HONDA

SERVICE BULLETIN

CB-750 RECALL FOR DRIVE SYSTEM MODIFICATION

750 #32
SUPPLEMENT #2
9/7/72

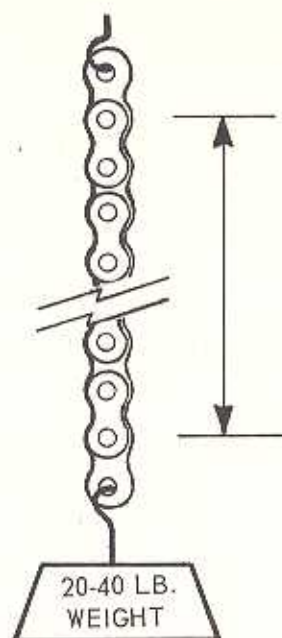
Replace any drive chain not marked , , or  regardless of the condition of the used chain. This authorization to replace extends even to makes of used drive chain not supplied by American Honda.

Replace any of the three types of drive chain indicated above only if any of the following conditions exist (if chain is excessively dirty, clean with solvent before checking):

- Damaged rollers.
- Loose pins.
- Binding links which cannot be freed.
- Overall length of chain exceeds service limits.

Straighten any stiff joints. Then measure chain length while chain is hung with a 20 to 40 lb. weight attached to the lower end. This procedure will ensure that the chain is fully extended when measured.

DRIVE CHAIN USED WITH CB-750, FRAME NUMBERS
CB750-1000001 THROUGH CB750-1044649:

97 LINKS (96 PINS) WITH MASTER LINK REMOVED.

SERVICE LIMIT 60 9/16", MEASURED FROM FIRST
PIN TO LAST PIN.
